**SUBJECT:** Remedial Action Implementation Plan for the Lower Three Runs Integrator Operable Unit Upper Subunit (U) (SRNS-RP-2022-00011, Revision 1 Redline, August 2022), Land Use Control Implementation Plan (LUCIP) for the Lower Three Runs Integrator Operable Unit (Upper Subunit) (U) (SRNS-RP-2022-00017, Revision 1 Redline, August 2022), and Monitored Natural Recovery Effectiveness Plan for the Lower Three Runs Integrator Operable Unit – Upper Subunit (U) (SRNS-RP-2022-00085, Revision 1 Redline, August 2022) SEMS Number: 35

**SRS Responses to South Carolina Department of Health and Environmental  
Control Comments on the Remedial Action Implementation Plan for the Lower  
Three Runs Integrator Operable Unit Upper Subunit (U)  
SRNS-RP-2022-00011, Revision 0, March 2022, SEMS Number: 35  
Savannah River Site NPL Site, South Carolina**

**SRS Responses to U.S. Environmental Protection Agency Comments on the  
Remedial Action Implementation Plan for the Lower Three Runs  
Integrator Operable Unit Upper Subunit (U)  
SRNS-RP-2022-00011, Revision 0, March 2022, SEMS NUMBER: 35  
Savannah River Site NPL Site, South Carolina**

Figure 4. Sample Locations that Exceed the Cleanup Levels in the Upper Subunit of the LTR IOU

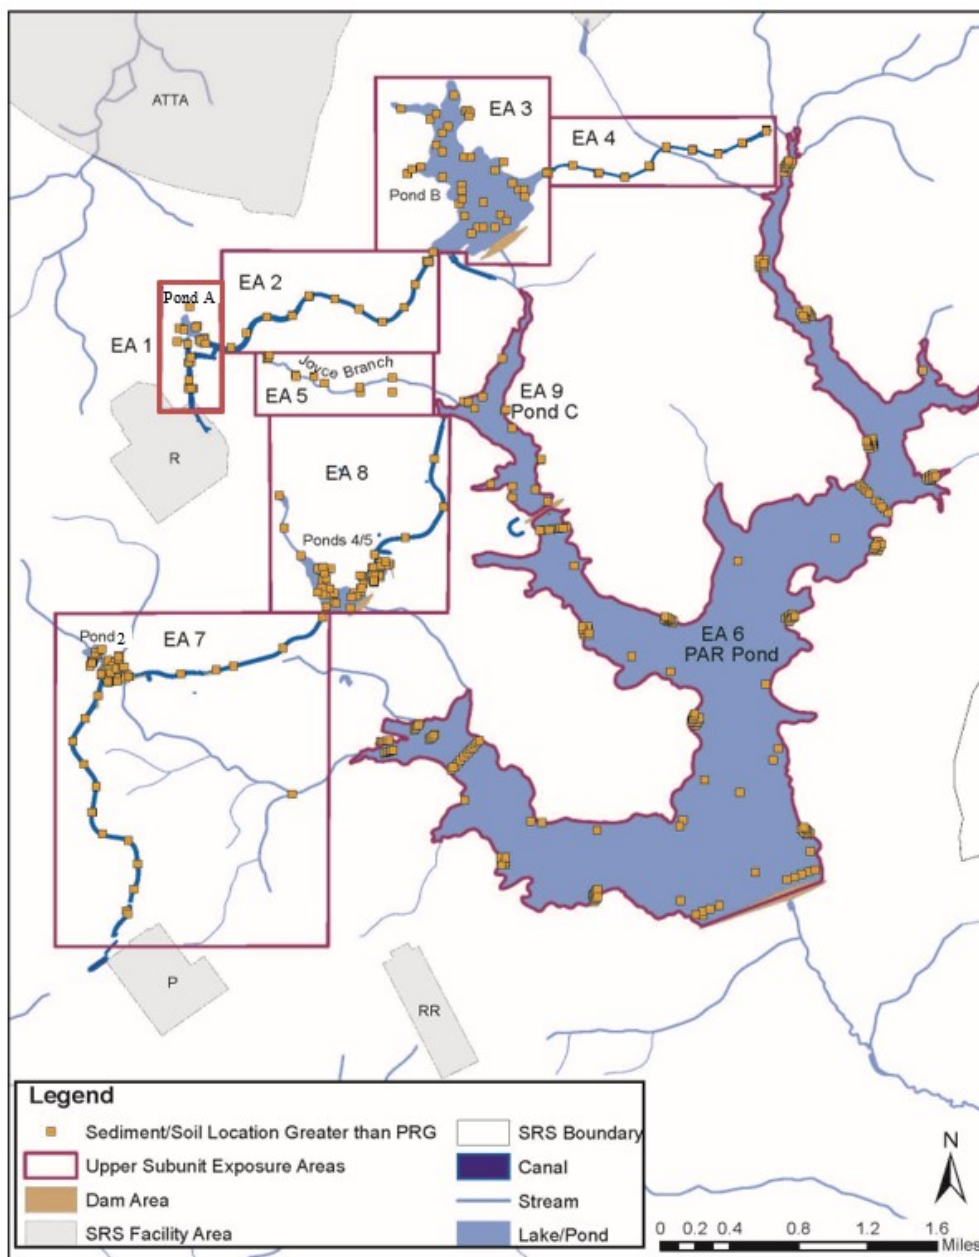
1. Except for the identification of Pond A on Figure B4 (Sampling Results from Locations within R-Area Discharge Canal, Page B-22 of B-28) of Appendix B [Field Sampling Plan (FSP) for Field Sampling Plan [sic] for Pre and Post PTSM Excavation for the R-Area Discharge Canal of Exposure Area 1 (EA1)], the location of Pond A included in exposure area (EA) 1 and Pond 2 included in EA7 are not identified on any figure prepared for the RAIP. Furthermore, the location of Pond A is misidentified on Figure 4 (Sample Locations that Exceed the Cleanup Levels in the Upper Subunit of the LTR IOU, Page 30 of 42) as being included in EA7. Please revise the figures as appropriate so the location of Pond A is clearly identified in EA1, as well as the location of Pond 2 in EA7.

- 3. Figure 4, Sample Locations that Exceed the Cleanup Levels in the Upper Subunit of the LTR IOU, Page 30 of 42:** The figure identifies Pond A as included in EA7; however, Pond A is the surface water body included in EA1 and Pond 2 is the surface water body included in EA7. Please revise the figure to identify the correct locations of Pond A and Pond 2.

**The document will be modified to properly identify Pond A on figures 4, 5, 6, 7, 9, and B4. Pond 2 will be correctly labeled on Figure 4.**

Figure 5. PTSM Locations for the Upper Subunit of the LTR IOU

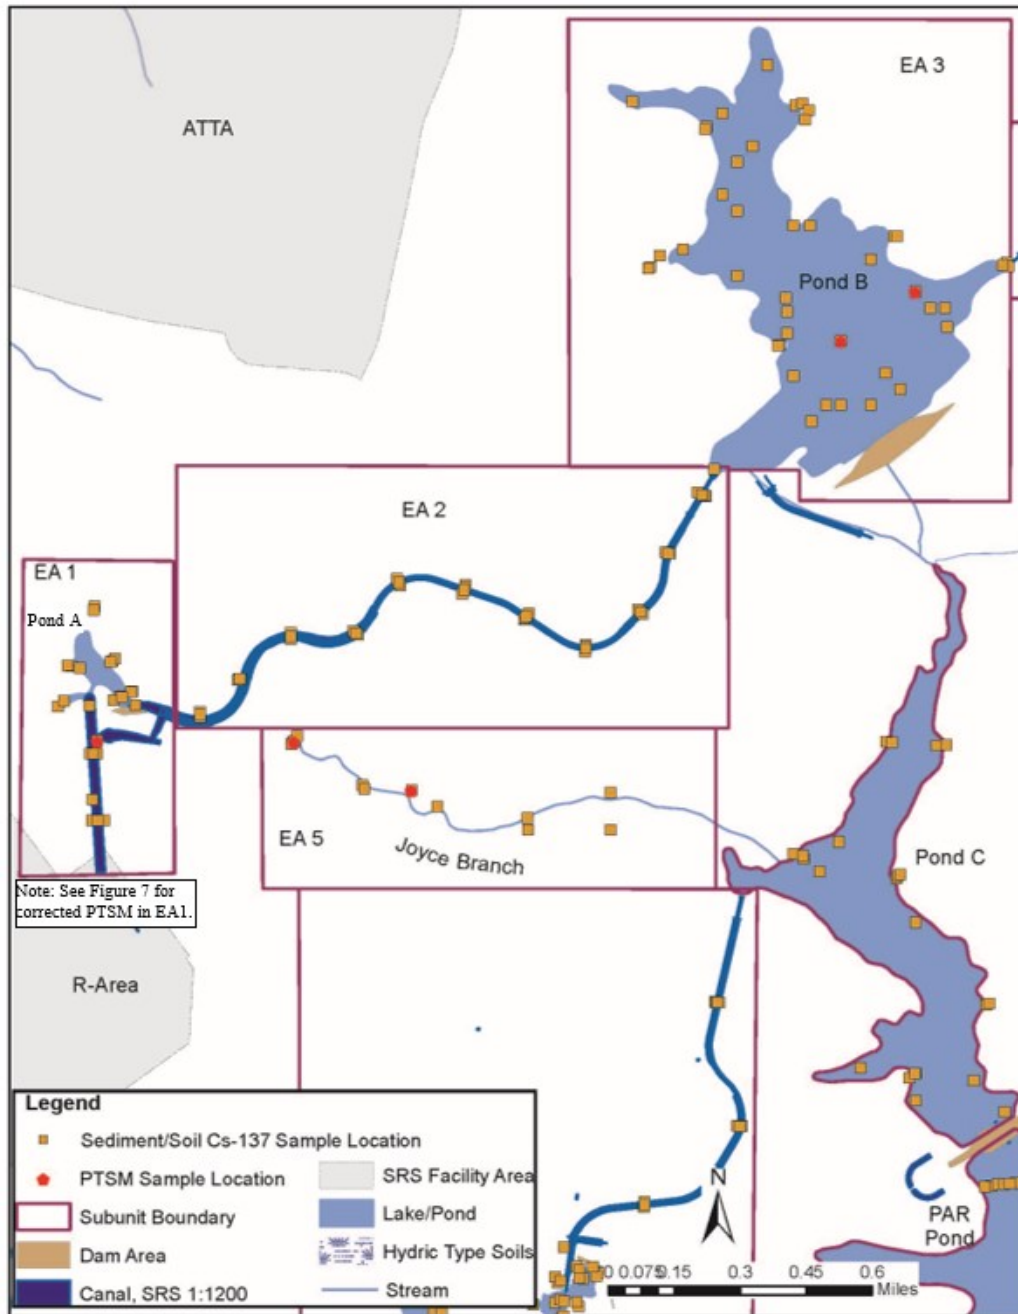
- 4. Figure 5, PTSM Locations for the Upper Subunit of the LTR IOU, Page 32 of 42:** The PTSM location in EA1 shown on Figure 5 is the previously mis-plotted and incorrect R-1, Downstream of R-Area location; however, this fact is not reflected in the figure legend. Please revise the Figure 5 legend to clarify the PTSM location shown on the figure is the previously depicted mis-plotted location R-1, Downstream of R-Area.

**A note will be added to Figure 5 to clarify that the correct PTSM location for EA1 is shown in Figure 7.**

**Figure 7. PTSM Location for EA1 in the Upper Subunit of the LTR IOU**

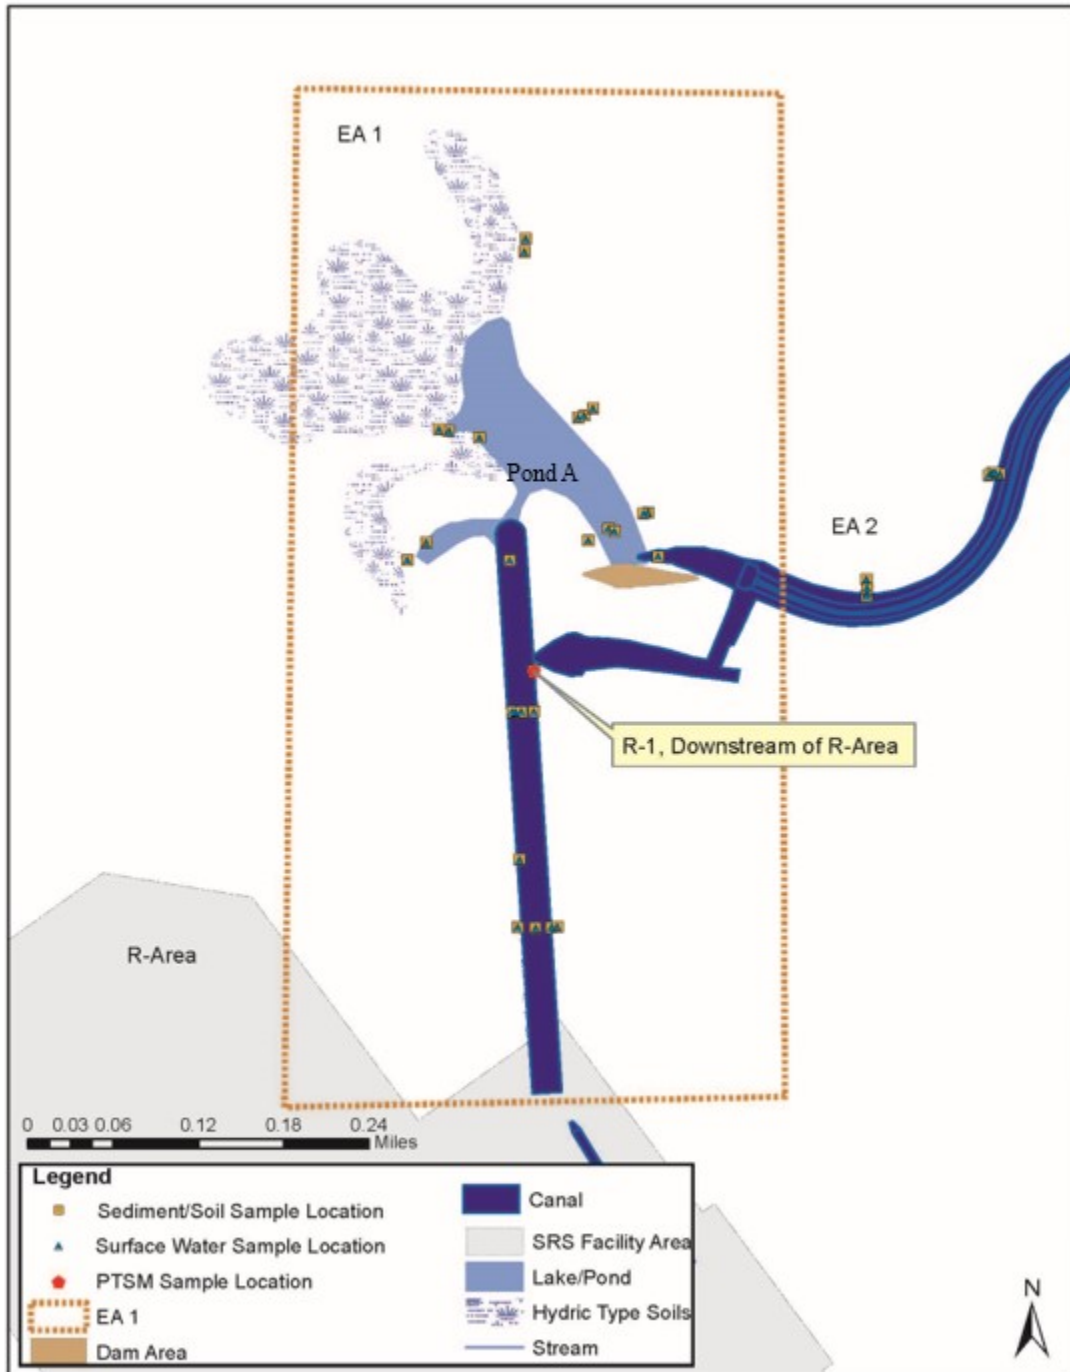
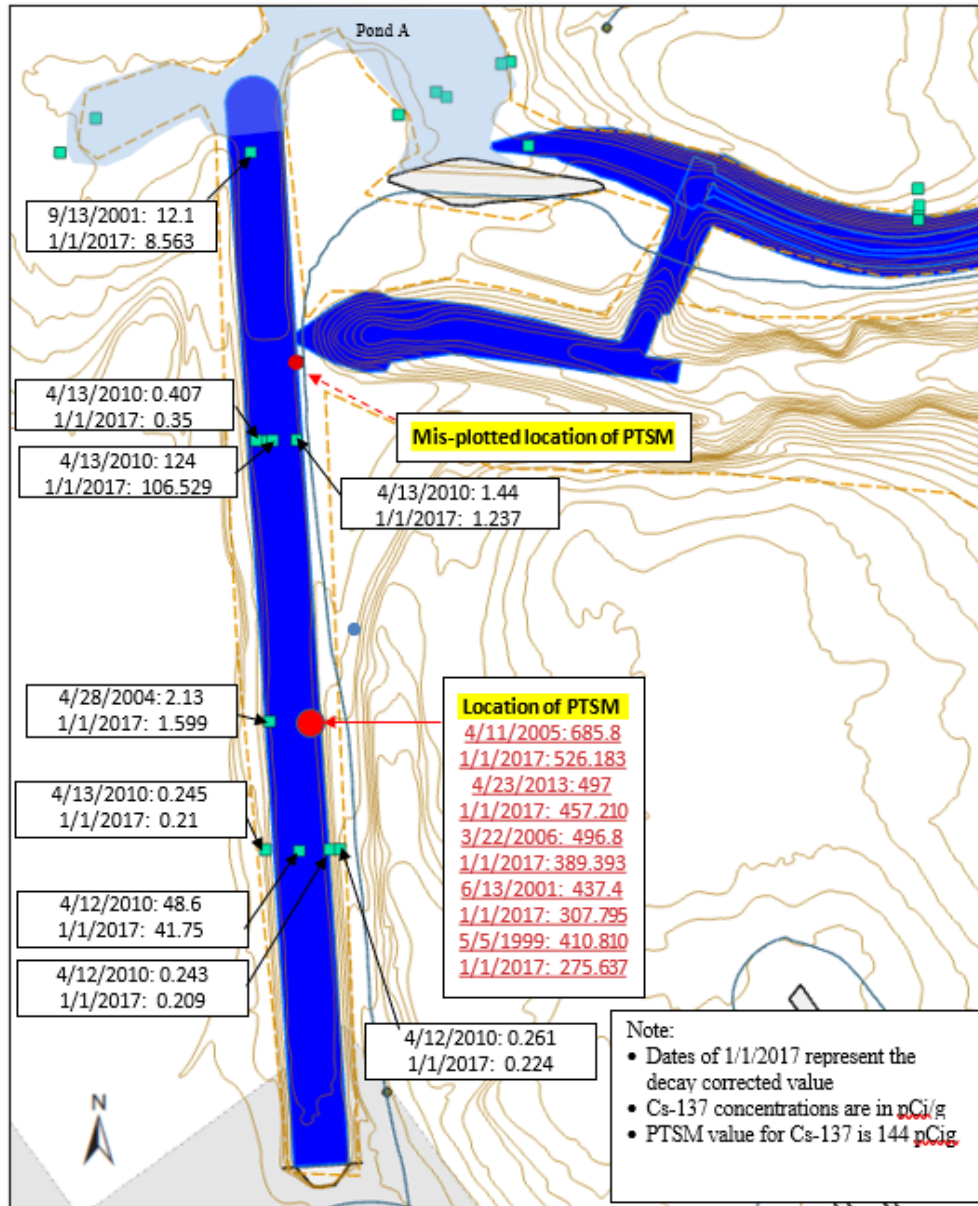
2. There is a discrepancy between the cesium (Cs)-137 data presented on Figure 7 (PTSM Location for EA1 in the Upper Subunit of the LTR IOU, Page 33 of 42) and the Cs-137 data presented on Figure B4 (Sampling Results from Locations within R-Area Discharge Canal, Page B-22 of B-28) of Appendix B [Field Sampling Plan (FSP) for Field Sampling Plan [sic] for Pre and Post PTSM Excavation for the R-Area Discharge Canal of Exposure Area 1 (EA1)]. As such, the data sets used for the principal threat source material (PTSM) characterization are unclear. For example, the text box on Figure 7 showing the location of PTSM indicates four results were greater than 400 picocuries per gram (pCi/g) with 2013 being the highest most recently. However, on Figure B4, the text box "Exceeds PTSM" indicates seven results were greater than 400 pCi/g with the most recent result of 526.183 pCi/g on 1/1/2017. Furthermore, Figure 7 shows sample LTROU-01 with a detection of 2.13 pCi/g located and adjacent to the PTSM; however, on Figure B4, the location of the 2.13 pCi/g result is depicted further to the south along the first transect line. Please revise the RAIP as appropriate to address the discrepancy in the reported data results between Figure 7 and Figure B4.

- 5. Figure 7, PTSM Location for EA1 in the Upper Subunit of the LTR IOU, Page 33 of 42:** The figure shows green squares for the locations where sediment/soil and surface water samples were collected north of the discharge canal; however, no blue shading is illustrated to indicate the presence of a surface water body (i.e., Pond A). Please revise the figure to include the blue shading to indicate the presence of a surface water body (i.e., Pond A) north of the discharge canal.

- 6. Figure 7, PTSM Location for EA1 in the Upper Subunit of the LTR IOU, Page 33 of 42:** The figure does not depict the locations of existing wells RPC-12DU and RPC-12C that are installed near the PTSM excavation area in EA1. In Attachment 1-3 (Preliminary Design Sketch for Excavation of

PTSM Sediments, Page Att1-5 of Att1-6) of Appendix B [Field Sampling Plan (FSP) for Field Sampling Plan [sic] for Pre and Post PTSM Excavation for the R-Area Discharge Canal of Exposure Area 1 (EA1)], existing wells RPC-12DU and RPC-12DL are shown installed to the east of the access road and proposed PTSM excavation area. Please revise Figure 7 to include the locations of existing monitoring wells RPC-12DU and PPC-12DL.

**Figure 7 of the RAIP will be revised to provide the data for the PTSM location, as well as other sampling points within the R-Area Discharge Canal as presented in Figure 3-10 of the Rev. 1 RI/BRA (SRNS-RP-2017-00139). Figure B4 will be revised to show the correct location and data for the sampling points directly across from the PTSM location and directly below that location, consistent with Figure 7. A note will be added to both figures to explain that the 1/1/2017 data is the calculated decay-corrected value.**

**Figure 7 will be modified to properly shade all water bodies as blue.**

The locations of RPC-12DU and RPC-12DL were included in Attachment 1-3, Preliminary Design Sketch for the Excavation of PTSM Sediments, to show potential interferences for equipment laydown and maneuverability for excavation activities. Adding just monitoring wells RPC-1DU and RPC-12DL to figure 7 would be an incomplete representation of monitoring wells in the LTR study area and is inconsistent with figures provided in previous documents. A note will be added to Attachment 1-3 explaining that the monitoring wells are shown for potential interferences for equipment mobility.

**Figure B4. Sampling Results from Locations within R-Area Discharge Canal**

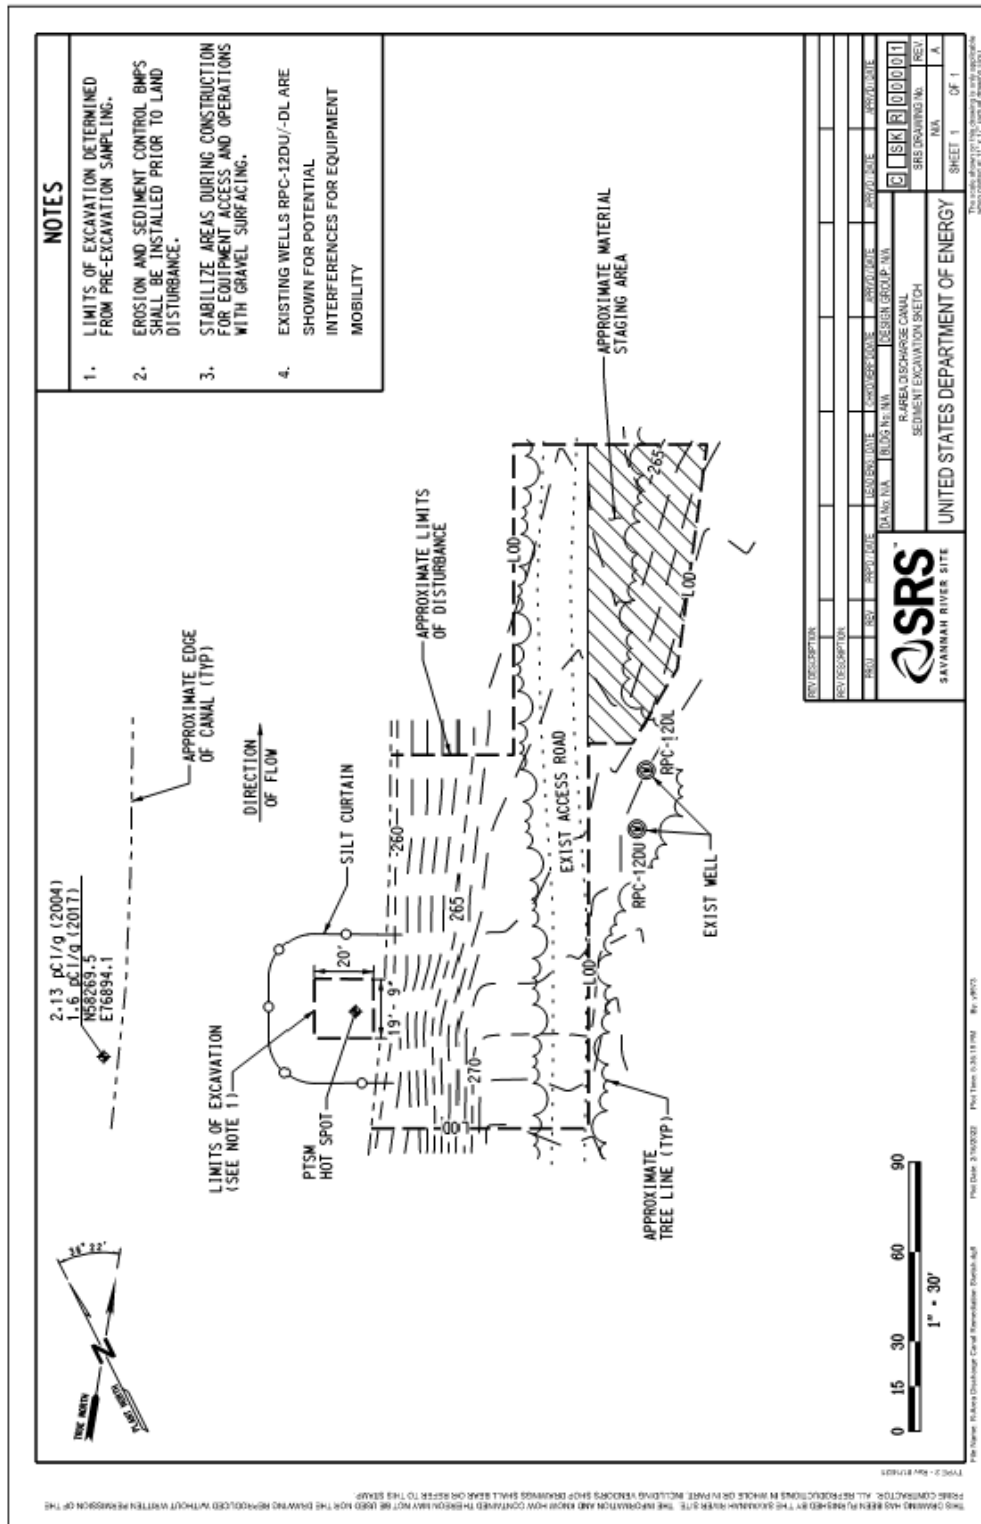
7. **Figure B4, Sampling Results from Locations within R-Area Discharge Canal, Appendix B, Page B-22 of B-28:** According to Figure B4, sediment/soil samples were collected on 1/1/2017 for Cs-137 analysis with results reported on the figure; however, the 2017 sampling event is not discussed in the RAIP, and it is unclear how this data set relates to the PTSM characterization. Please revise the RAIP to address this issue by clarifying the use of the 2017 data set for PTSM characterization.

The PTSM evaluation used decay corrected values to calculate the exposure point concentration. The 1/1/2017 data in Figure B4 represents the calculated decay value. A note will be added to Figure B4 and Figure 7 to explain the 1/1/2017 data. In addition, the text in Appendix B, Section 2.3, will be modified as follows:

**“Figure B4 summarizes the Cs-137 concentrations that have been detected (and calculated decay-corrected values) in the R-Area Discharge Canal as compared to the preliminary remedial goal (PRG) of 0.144 pCi/g and the PTSM threshold (144 pCi/g). Table B1 provides a summary of the results from all samples collected in EA1 which includes the R-Area Discharge Canal and Pond A. Contaminant concentrations were compared to USEPA Preliminary Remediation Goals (PRGs) for radiological contaminated media. Decay-corrected values were used to develop the exposure point concentrations for the PTSM uncertainty evaluation.”**
